# Planning Response

Flosh Meadows

The Meadows (SR12, SR12A, Top Meadows)

1842-PR2

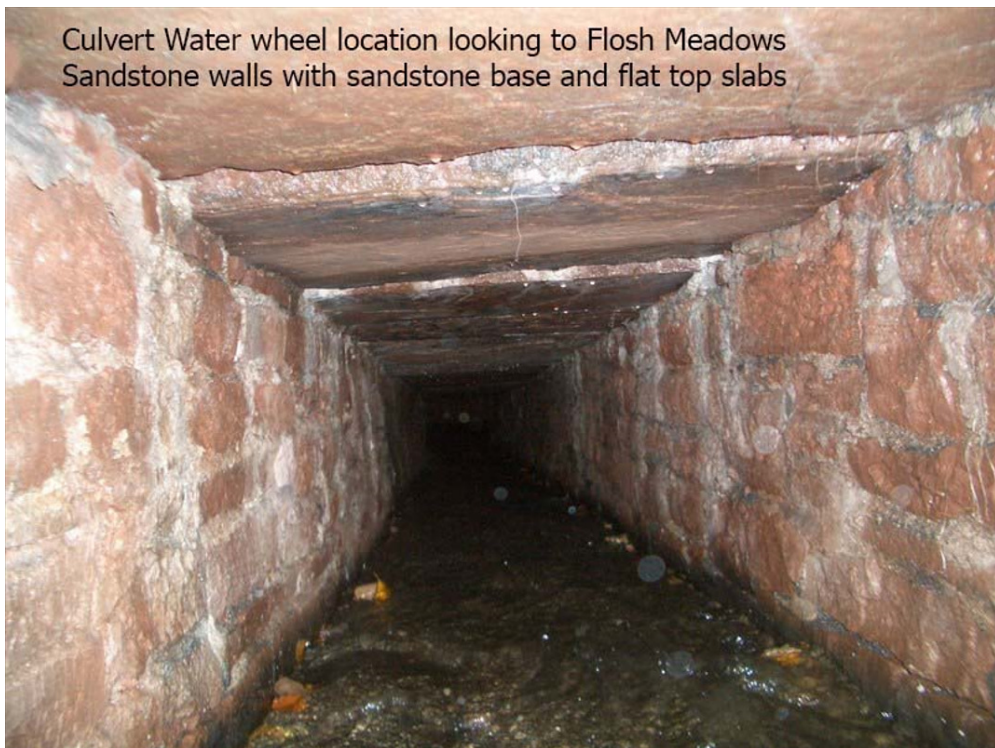
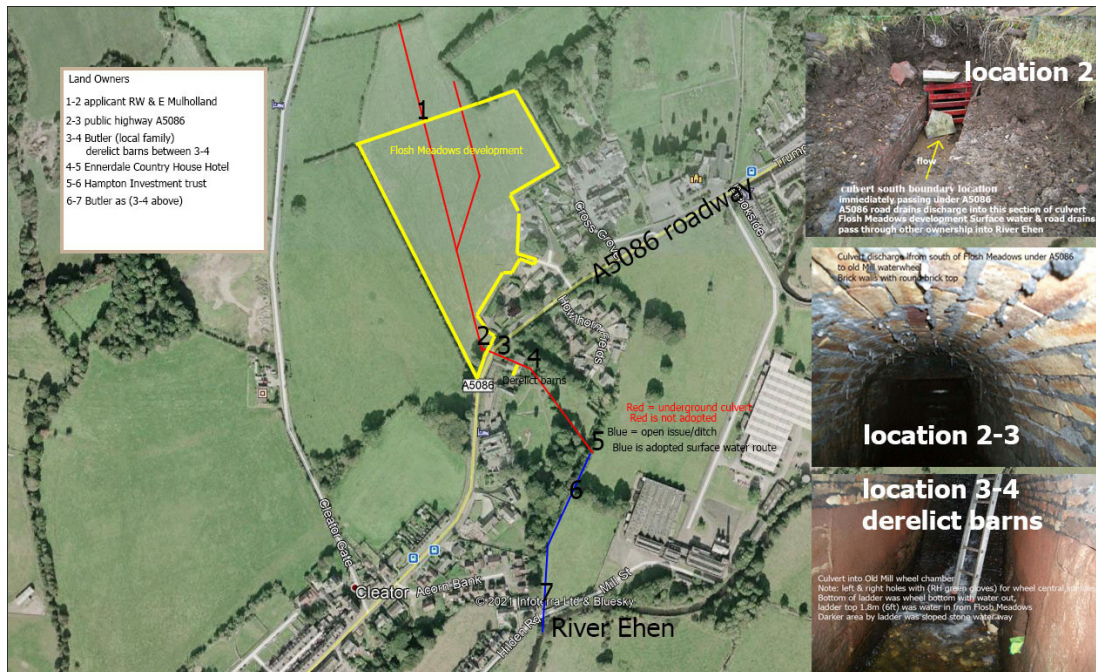
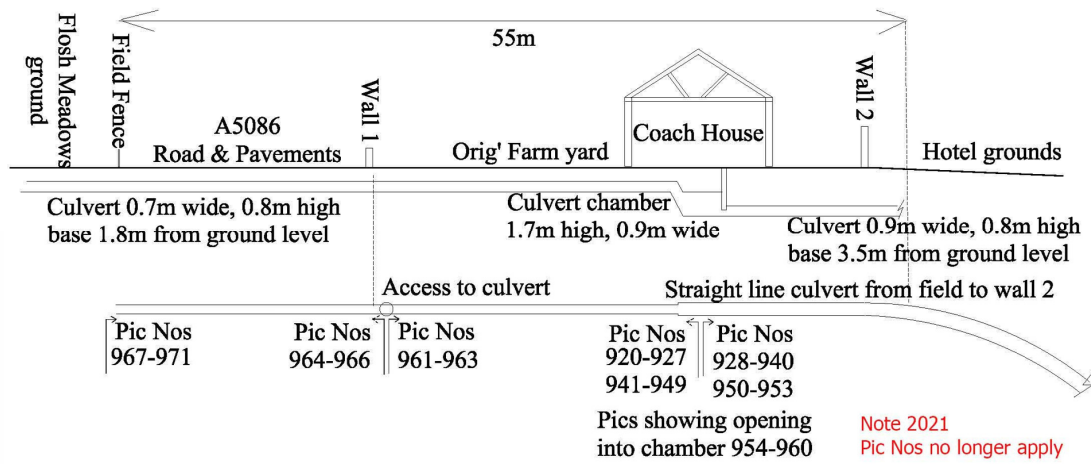
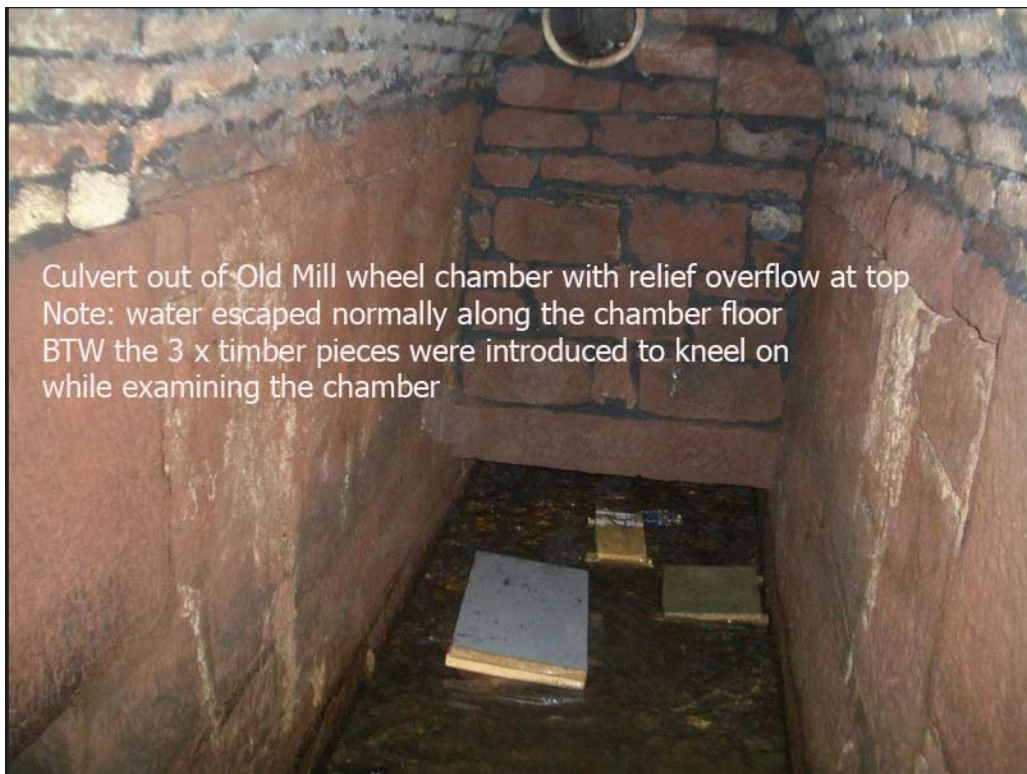
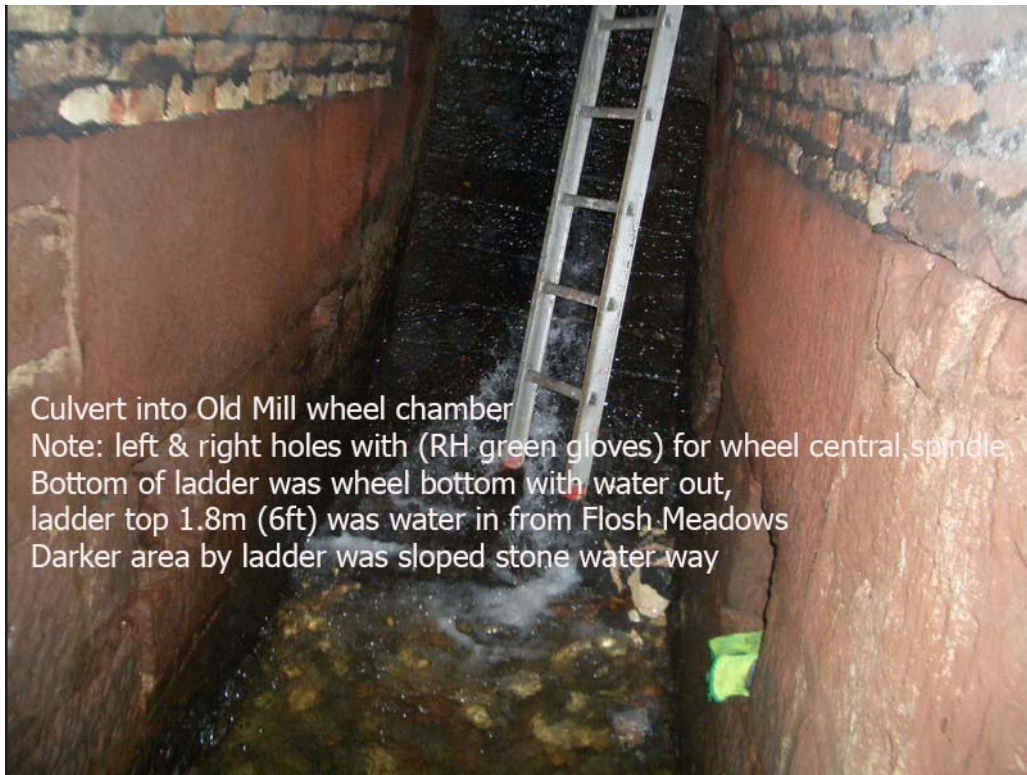
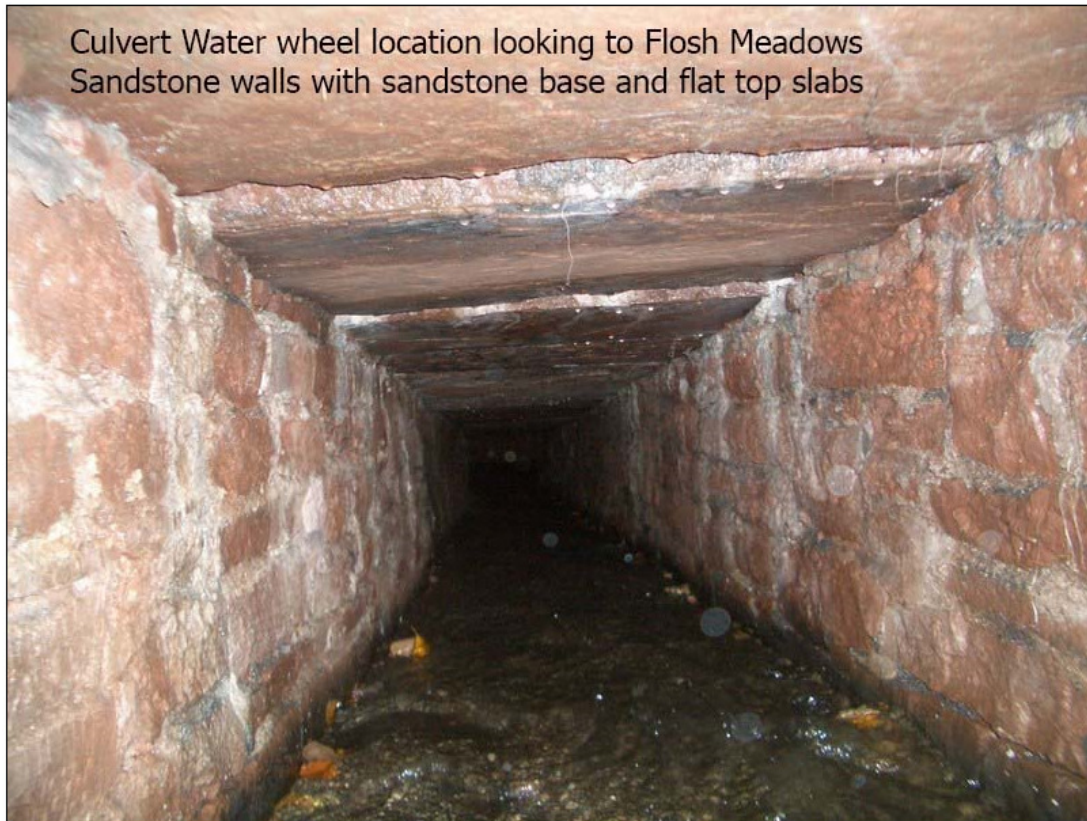
- 2.01   **LLFA comment** - *Regarding the 'mill races'. Despite what you say in the report and the sketch plan, I have studied the topography and old OS maps and can see no evidence of there being a mill that these could feed, nor a watercourse that could feed these races. It is clear from old OS maps that the two mills just off the River Ehen were fed from mill races placed just above weirs as is normal for mills. So I think we will have to agree to disagree that these are mill races. They are more likely part of the land drainage system to drain the clay soil and improve the ground. In which case these would become riparian ownership drains or watercourses.*

Attached are pictures showing the substantial water wheel location with required mill race & onward culvert to the River Ehen. All can be seen to be built to an exceptionally high standard to service the mill.

The Mill race and water wheel location with highly engineered culverts are still in existence.
